Submission on Reference: SSD 5066/EPBC 2011/6086 Provided by Allan Corben 13 Woolmer's Court Wattle Grove NSW 2173 P/N 0451 998 774 Email allancorben@bigpond.com

MICL EIS notes Chapter 12 Noise & Vibration

Page 44 Controlling noise propagation

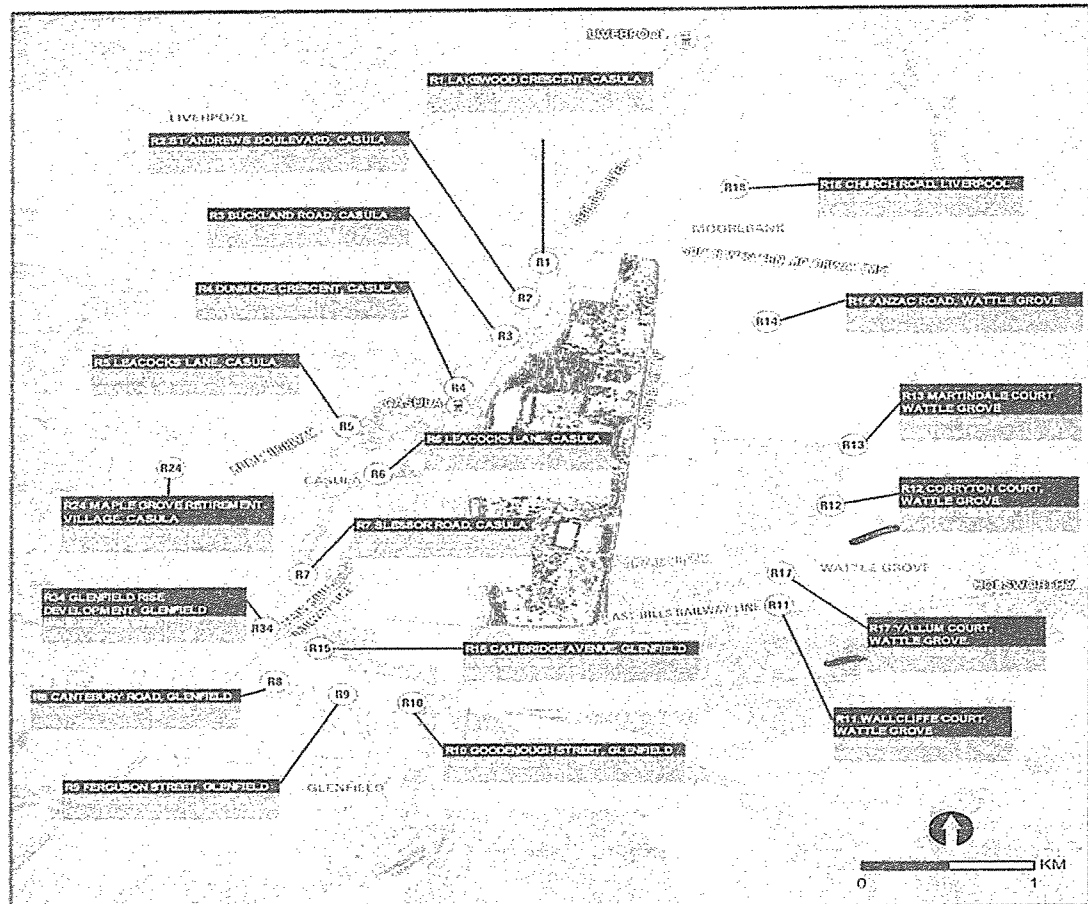
TEU containers could be used as noise barriers where they are stacked, to eliminate gaps or openings and to effectively impede the direct line of sight to nearest receptors. This is likely to require an operational management procedure to ensure the container areas adjacent to the residential communities are maintained so that the containers are at the maximum practicable height at all times (typically up to five TEU). ***This statement is open ended and is in no way any form of guarantee as M/T TEU's might not be available to ensure that the impacted residents are consistently protected 24/7***
